# Access Compliance Report

## Public Rights-of-Way

### (Curb Ramps)

Intersection ID: 24040	Main Street: FOX_CHAPEL_LN	Cross Street: HAWK_CREST_CT	Location:	N
ADA ID: 0971DE53CA3B	Ramp Type: BlendTrans1	Initial Pass/Fail: Fail	Overall Compliance: No	Severity Score: 25

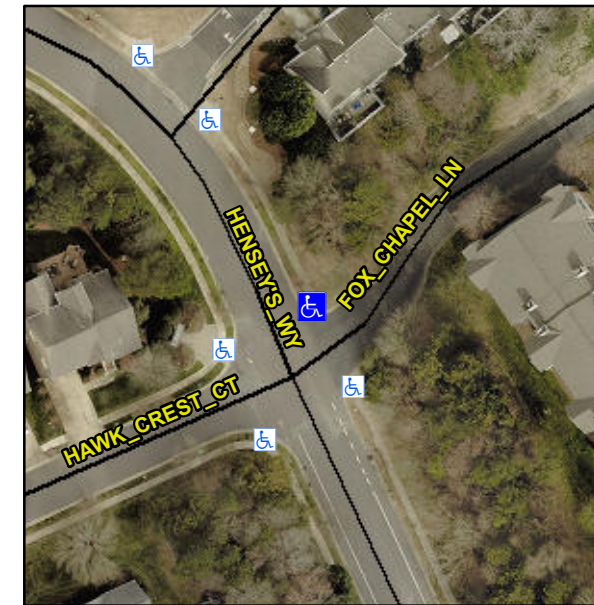
**Not Found, R304.5.3**

Compliance	Description	Data	Compliance	Description	Data
N/A	Ramp Length (in)	50.0	Yes	BlendTrans Slope (%)	1.2
Yes	Ramp Width (in)	48.0	No	BlendTrans XSlope (%)	11.1
N/A	Flare Type LT	N/A	N/A	Flare Type RT	N/A
N/A	Flare Slope LT (%)	N/A	N/A	Flare Slope RT (%)	N/A
N/A	Flare Traversable LT?	N/A	N/A	Flare Traversable RT?	N/A
N/A	Landing Length (in)	N/A	N/A	DWS Provided?	N/A
N/A	Landing Width (in)	N/A	N/A	DWS Contrast?	N/A
N/A	Landing Slope (%)	N/A	N/A	DWS Length (in)	N/A
N/A	Landing X Slope (%)	N/A	N/A	DWS Full Width?	N/A
N/A	Landing Curb? (Y/N)	N/A	N/A	DWS Offset (in)	N/A
N/A	Shared Landing?	N/A			
N/A	Gutter Ponding?	N/A	N/A	Gutter Slope (%)	N/A
N/A	Gutter Lip Ht (in)	N/A	N/A	Gutter X Slope (%)	N/A
N/A	Painted X Walk1?	No	N/A	Painted X Walk2?	No
	X Walk 1 Direction	To SW		X Walk 2 Direction	To SE
	X Walk 1 Width (in)	N/A		X Walk 2 Width (in)	N/A
	X Walk 1 Slope (%)	3.4		X Walk 2 Slope (%)	1.0
	X Walk 1 X Slope (%)	2.1		X Walk 2 X Slope (%)	9.4

N/A	Ramp inside XWalk1?	N/A	N/A	Ramp inside XWalk2?	N/A
	Road Slope (%)	8.2		Clear Space?	N/A
	Road X Slope (%)	5.1	N/A	Clear Space to XWalk (in)	N/A
N/A	Any Obstructions?	N/A	N/A	Storm Grate/Utility Hazard?	N/A
	Obstruction Type			Storm Grate/Utility Type	
		N/A			N/A
			Yes	Surface Condition? (G/P)	Good
			No	Curb Slope (%)	15.1

**Remove & Replace Curb Ramp With Two New Directional Ramps or Equivalent.**
